APPLICATION NUMBER: 24/0678

PROPOSAL: PROPOSED DEVELOPMENT OF 42 NO. DWELLINGS, LANDSCAPE PLANTING AND ASSOCIATED WORKS

SITE: Monbank Development Site Cardiff Road

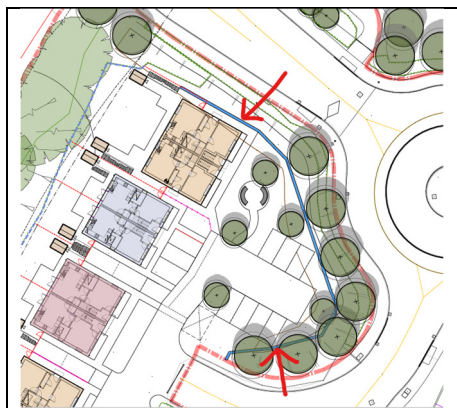
The Site Plan needs updating to reflect the Engineering Layout. The Site Plan shows a long retaining wall wrapping around the southern area (see below), but this is not shown on the engineering layout, and the public open space with attenuation basin also does not match up. The Planting & Management Plan appears to reflect the Engineering Layout.

Revision to the site plan and planting plan is recommended to mitigate the following issues:

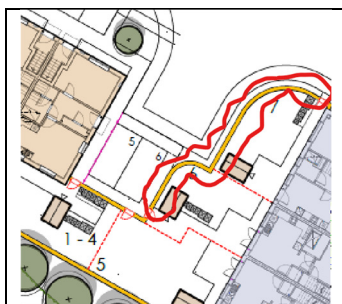
- At the location below, 1.8m high brick walls are proposed but there is no set back to allow for a planting strip to soften, this will result in an unattractive landscape and will heat up in summer.

- Some parking bays are shown with no buffer onto the brick wall, a planted strip is recommended to accommodate vehicle overhang.
